South Texas Project Electric Generating Station P.O. Box 289 Wadsworth, Texas 77483

September 29, 1998  
NOC-AE-0231  
File No.: G20.02.01  
G21.02.01  
10CFR50.90

South Texas Project  
Units 1 and 2  
Docket Nos. STN 50-498 and STN 50-499  
Proposed License Amendment Associated with Revised Calculation Methodology  
for Loss Of Coolant Accident Mass and Energy Release Analysis

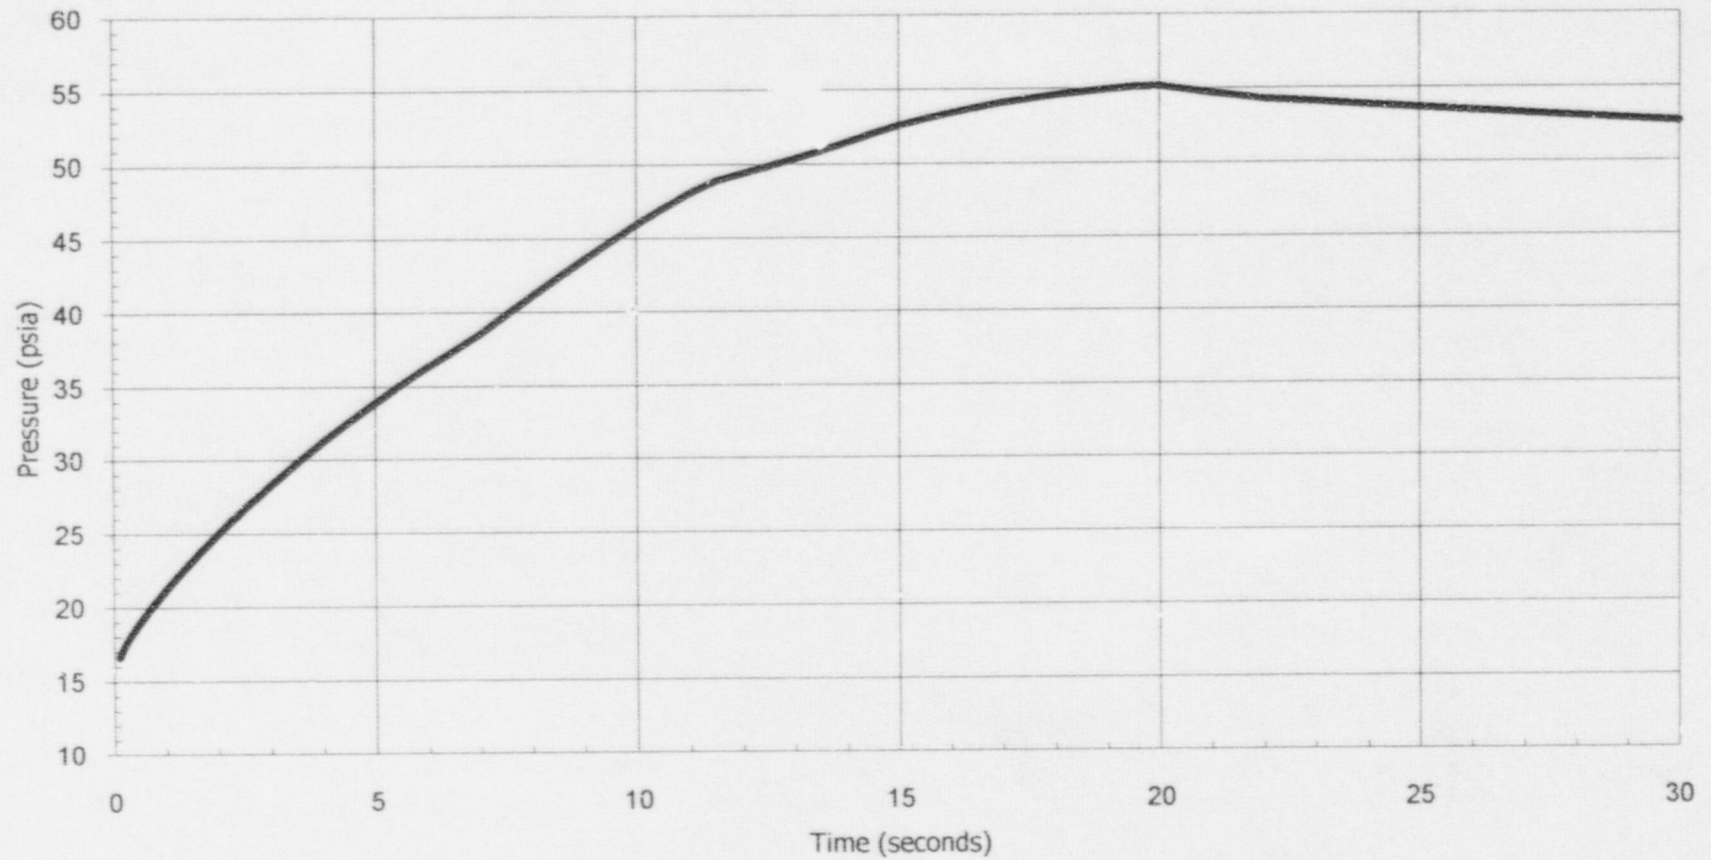
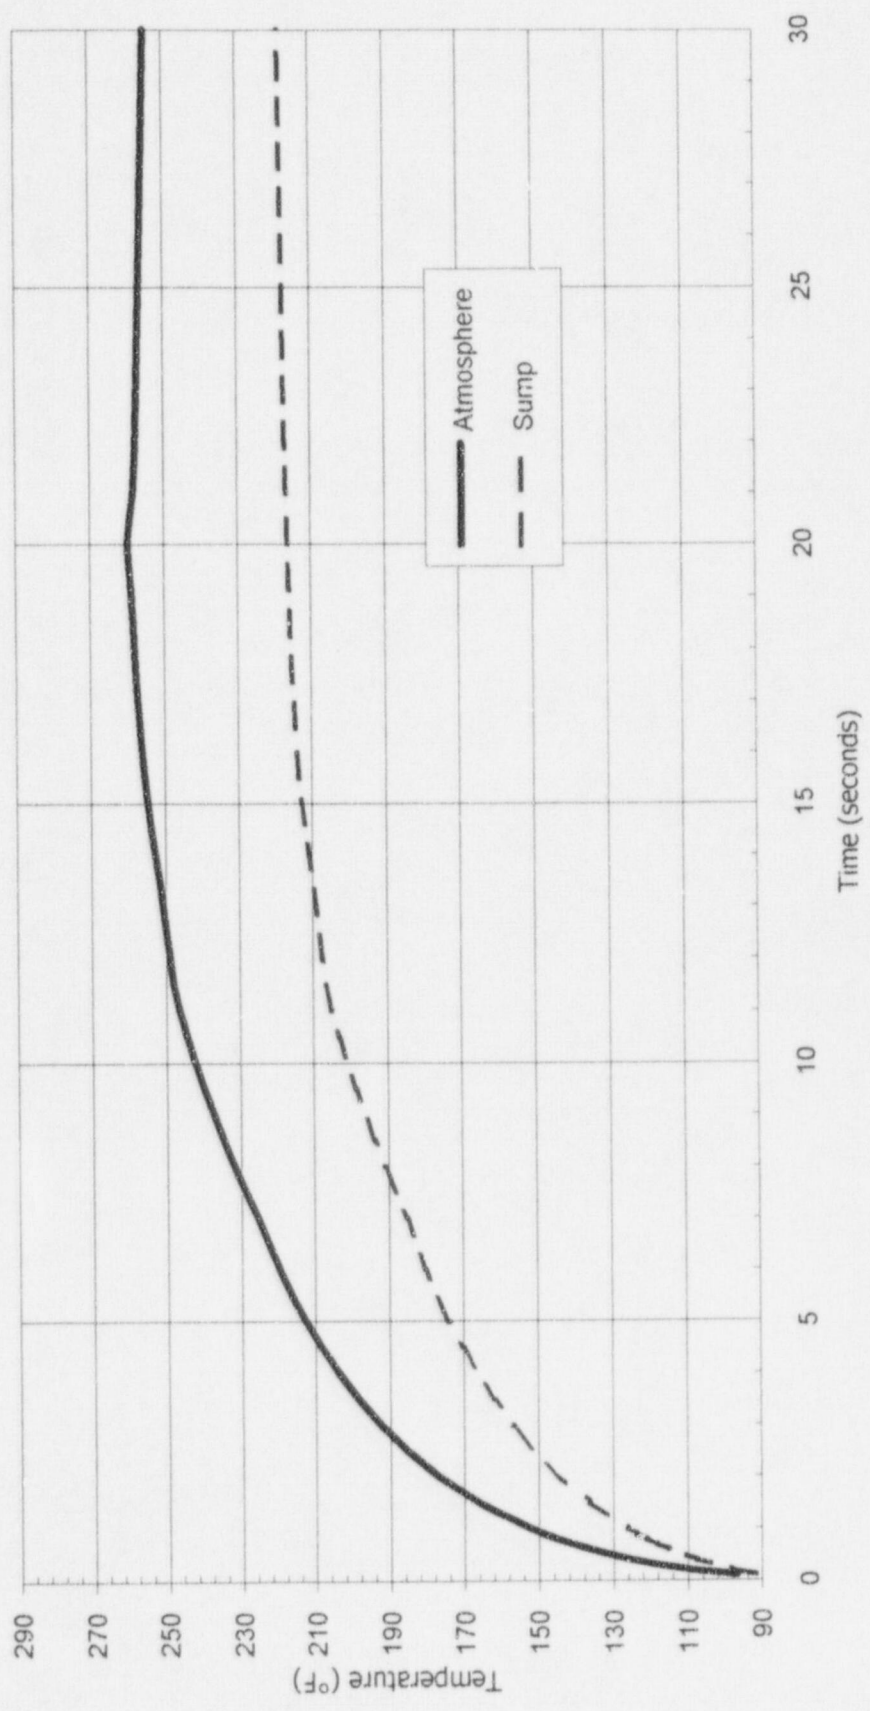
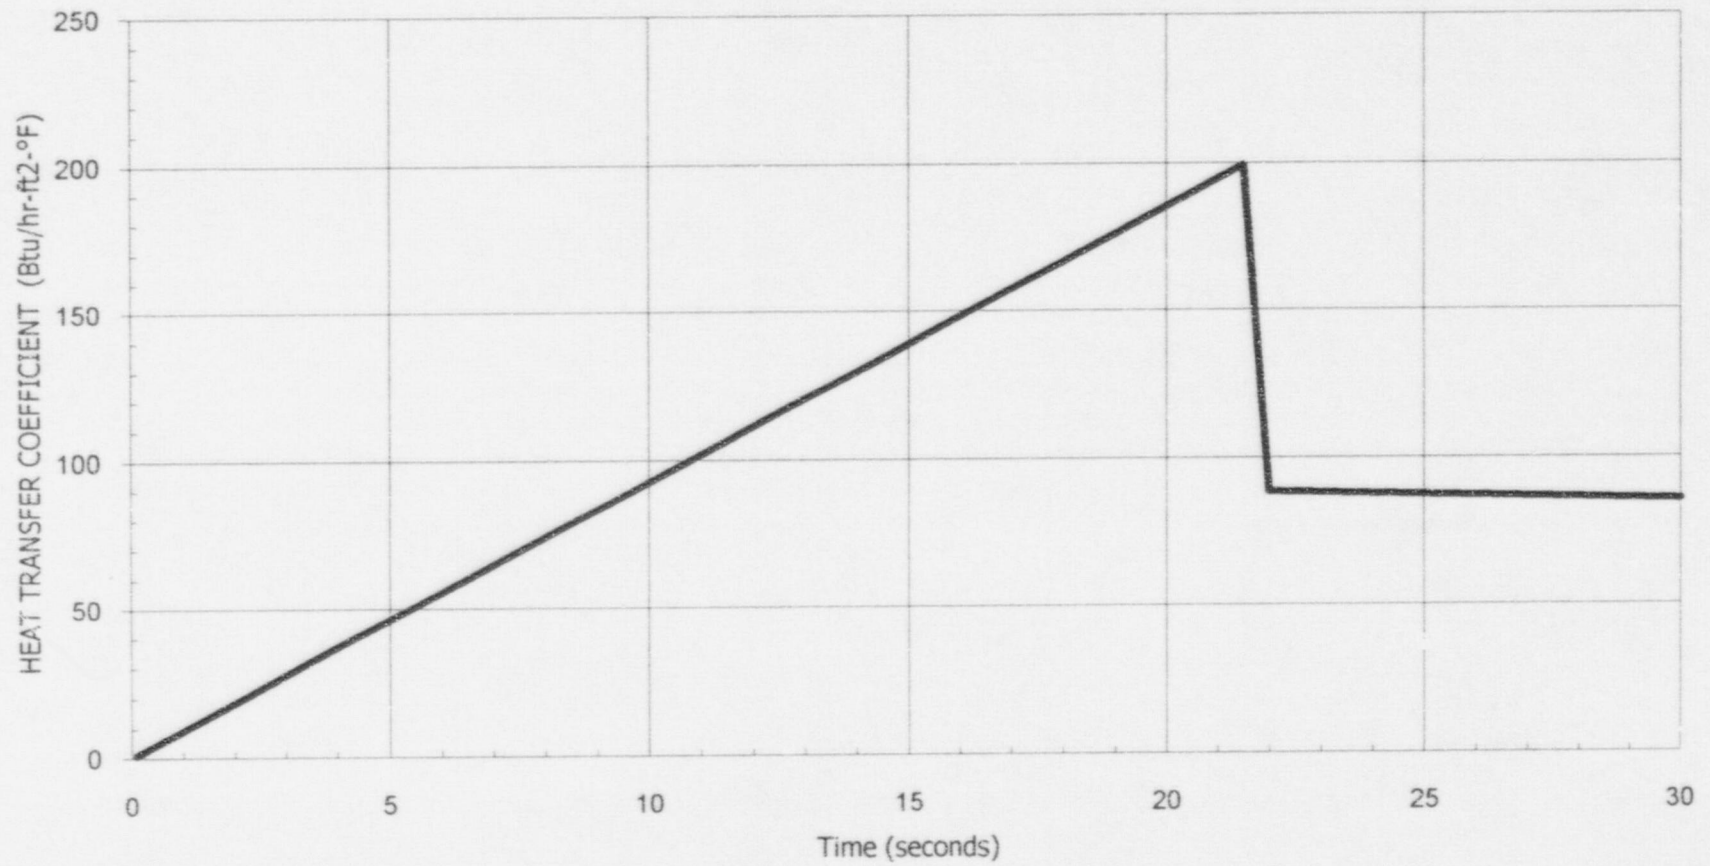
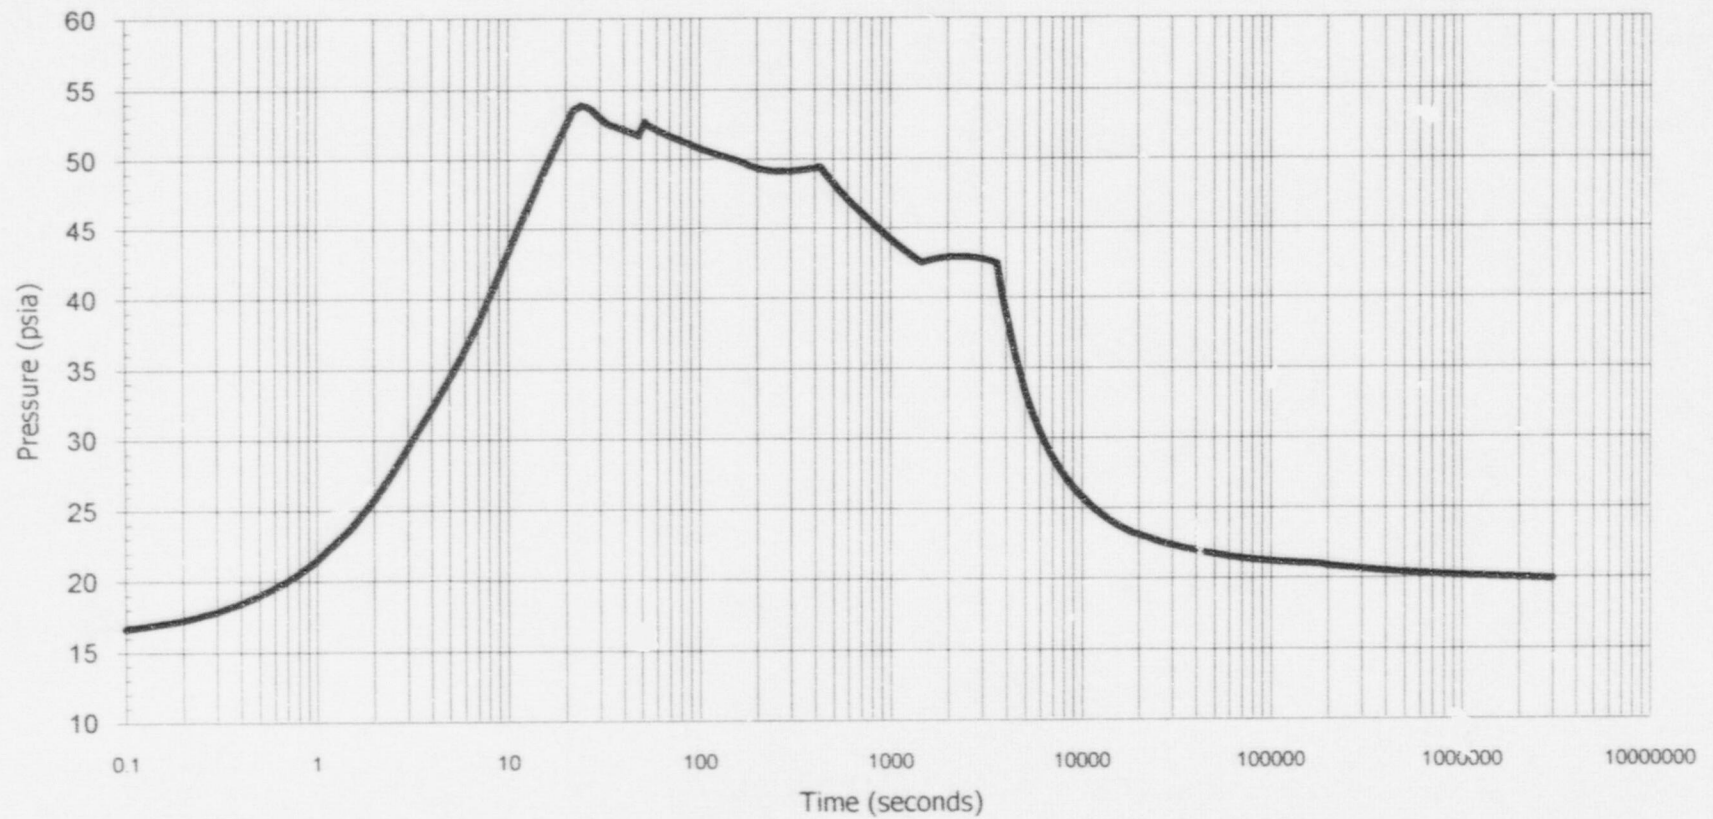
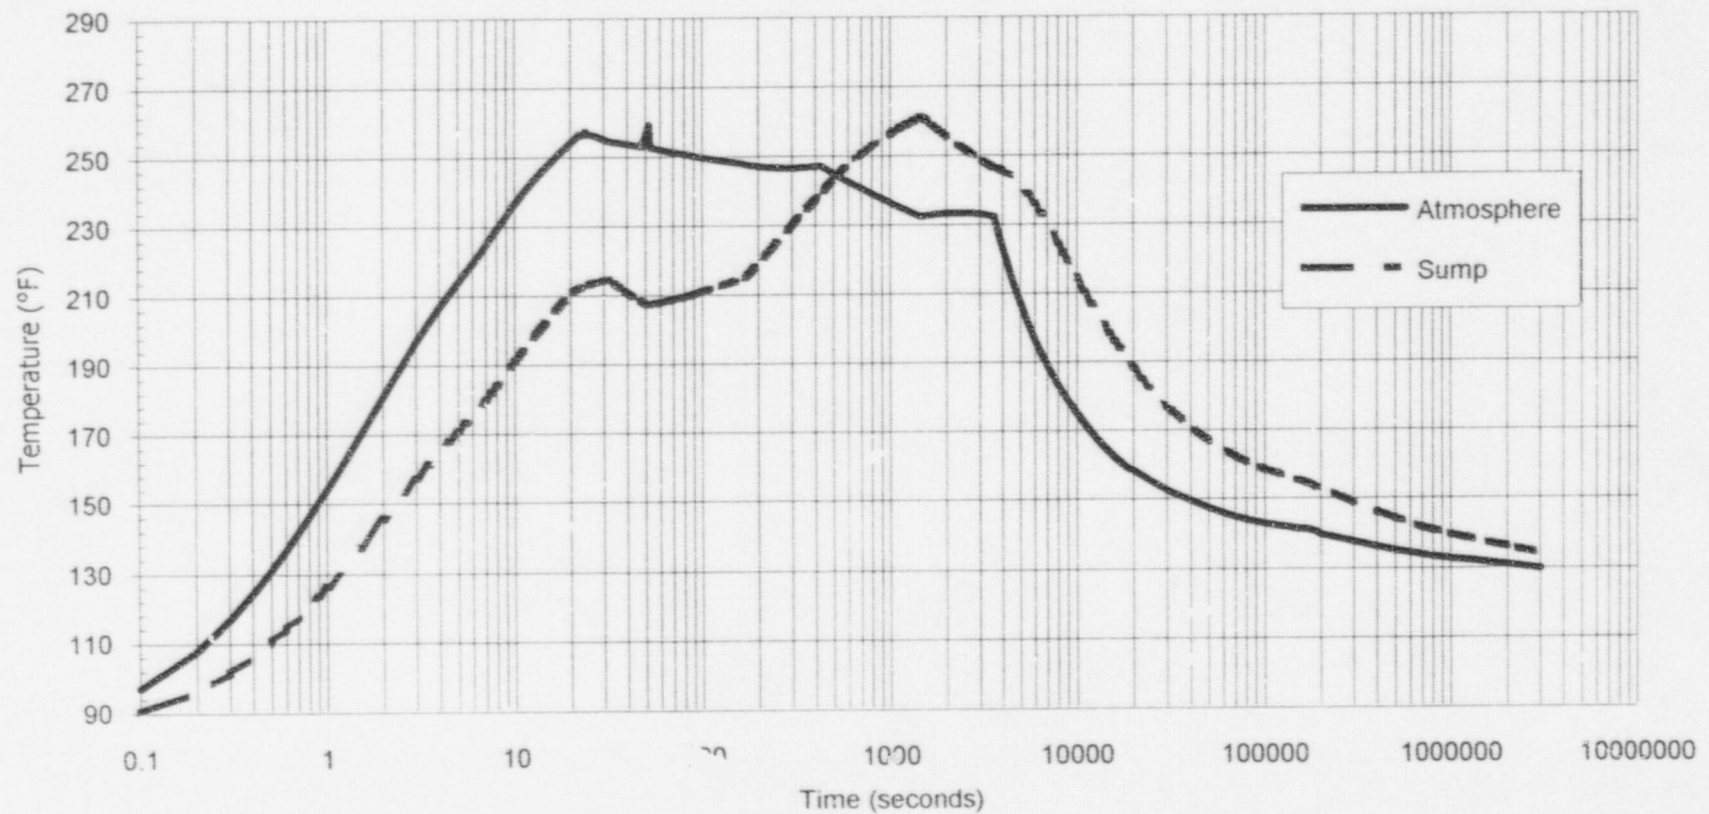
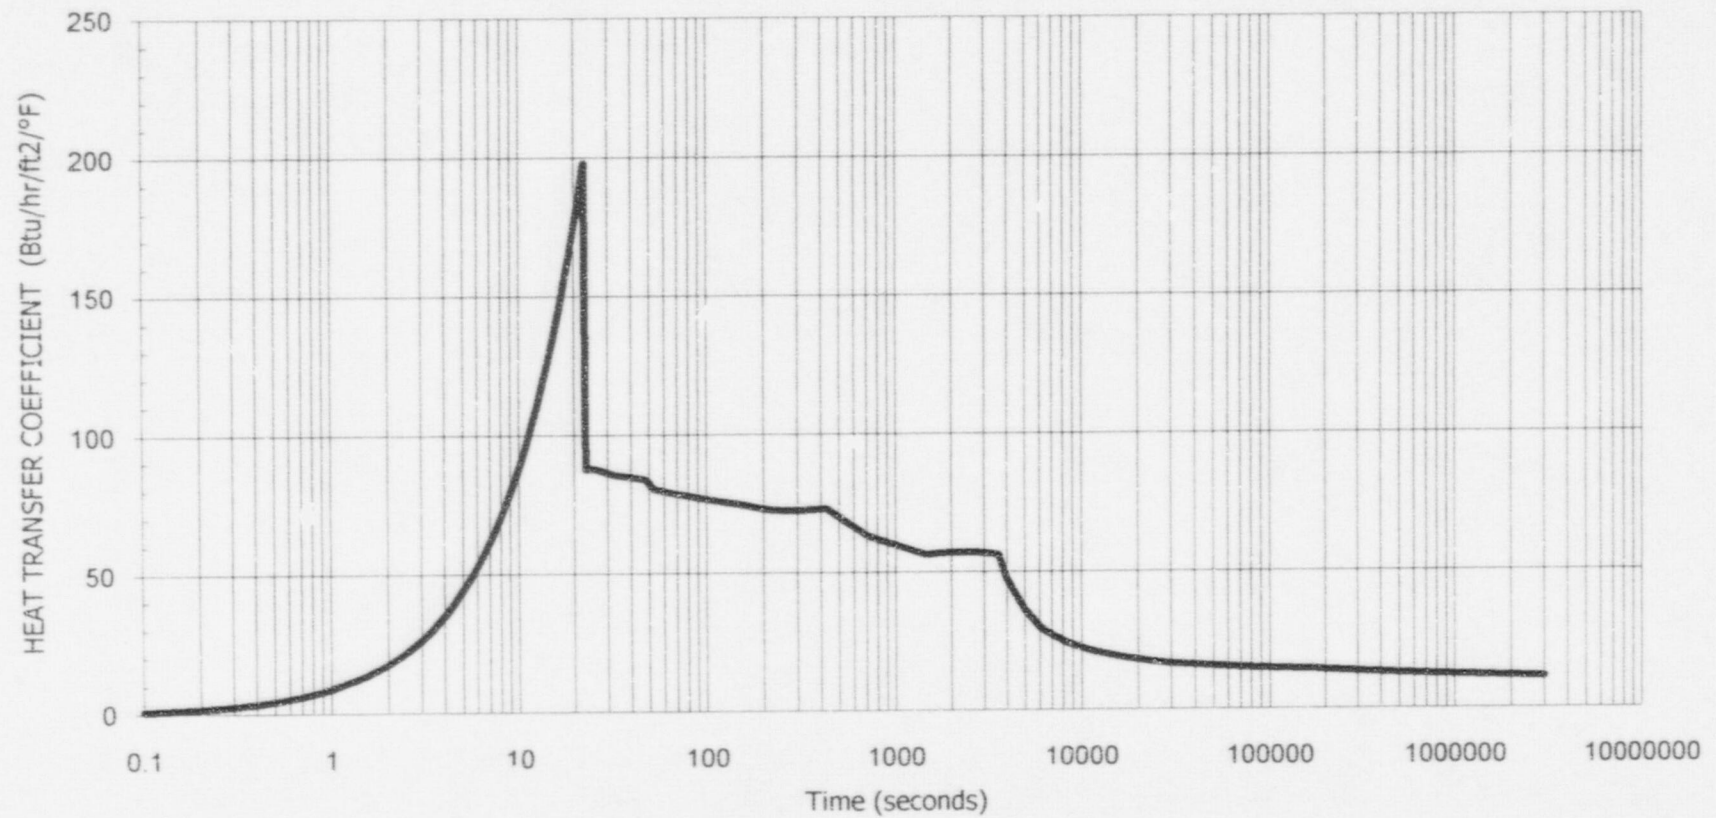
Containment pressure and temperature analyses results for  $\Delta 94$  steam generators are provided in attached UFSAR markups:

- Table 6.2A.1.1-4, summary of design basis LOCA containment pressures and temperatures.
- Figures 6.2A.1.1-30 to --38, pressure, temperature, and heat transfer coefficient profiles,

Figures 6.2A.1.1-30 through -38 provide plots of various Containment thermodynamic parameters as a function of time for the analyzed DEHL and DEPSG breaks.
